Memorandum

RE: Supplemental Information concerning PD amendment for Blues Creek, Unit 5, Phase 2 (PB-15-115 PDA)

Date: February 17, 2016

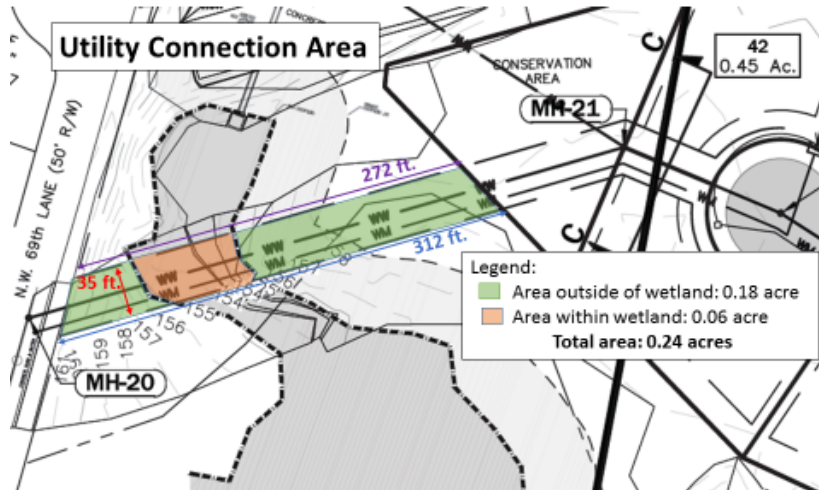
Q4. How large is the area within the “drainage easement, developed recreation, & conservation area” where the jack and bore connection will be made?

The proposed utility easement area is 35 feet wide for a distance of 272+/- feet on the north side and 312+/- feet on the south side. The following information provides data on the area within the easement.

The sewer pipe casing diameter is 18 inches (steel casing ¼ inch thick) and the PVC sewer pipe itself is 8 inches in diameter. The water pipe casing diameter is 16 inches the (PVC water pipe is 8 inches in diameter). The electrical conduit (if needed) will be 4

inches in diameter. The sewer pipe must be separated from the water pipe by 10 feet. The electric line must be separated by 3 feet from the water line. The diagram below illustrates the utility crossing area.
